Item Name: Crosstube Assembly, Mid Fwd

DART AEROSPACE LTD		Work Order:	108682
Description: Crosstube Assembly, Mid Fwd		Part Number:	D206-667-147
Inspection Dwg: D206-667-147 Rev: A		Page 1 of 2

DART AEROSPACE LTD HAWKESBURY, ONTARIO, CANADA	
DRAWING NO. D206-667-147	REV. A SHEET 1 OF 4
TITLE CROSSTUBE ASS'Y (206L MID FWD)	SCALE NTS

DRAWING NO. D206-667-147	TITLE CROSSTUBE ASS'Y (206L MID FWD)	REV. A	DART AEROSPACE LTD ENGINEERING ORDER	D.E.O. NO. D206-667-147-A-1	SHEET NO. SHEET 1 OF 1	SCALE NTS
DRAWN 9P	CHECKED ADS	MFG. APPR. PB	APPROVED MD	DE APPR. H		
DATE 11.07.15	DATE 11.07.20	DATE 11.07.21	DATE 11/07/21	DATE 11.07.21

DETAIL P
BONDING STRAP INSTALLATION 2 PL

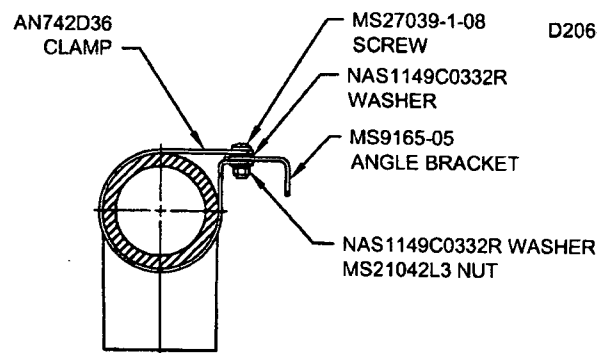
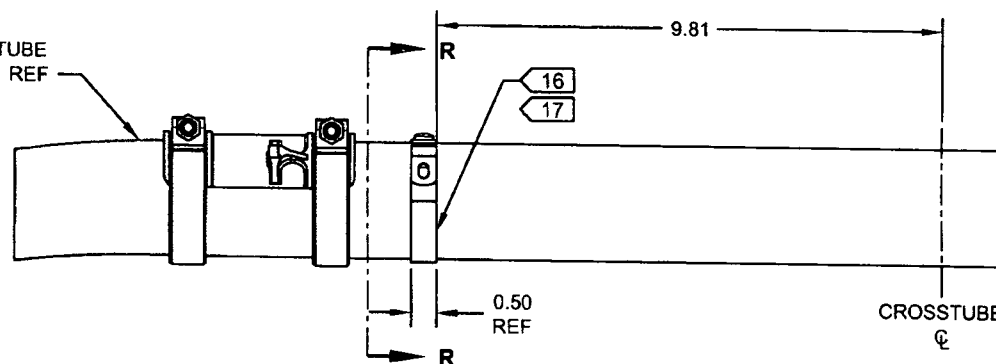
ADD ELECTRICAL GROUNDING STRAP

ITEM	QTY -147	PART NUMBER	DESCRIPTION
1	X	D206-667-147	CROSSTUBE ASSEMBLY (206L MID FWD)
10	2	AN742D36	CLAMP
11	2	MS9165-05	ANGLE BRACKET
12	2	MS21042L3	NUT (OR MS21042-3)
13	2	MS27039-1-08	SCREW
14	4	NAS1149C0332R	WASHER (OR AN960C10L)

- 16) MASK AREA UNDER CLAMP PRIOR TO PAINTING
- 17) SEAL EDGES WHERE AN742D36 CLAMP MEETS WITH THE CROSSTUBE USING SIKAFLEX-241/-291 OR MIL-S-8802 CLASS B2 OR PROSEAL 890 SEALANT
- 18) PERFORM RESISTANCE CHECK TO ENSURE MAX RESISTANCE IS 10 MILLIOHMS
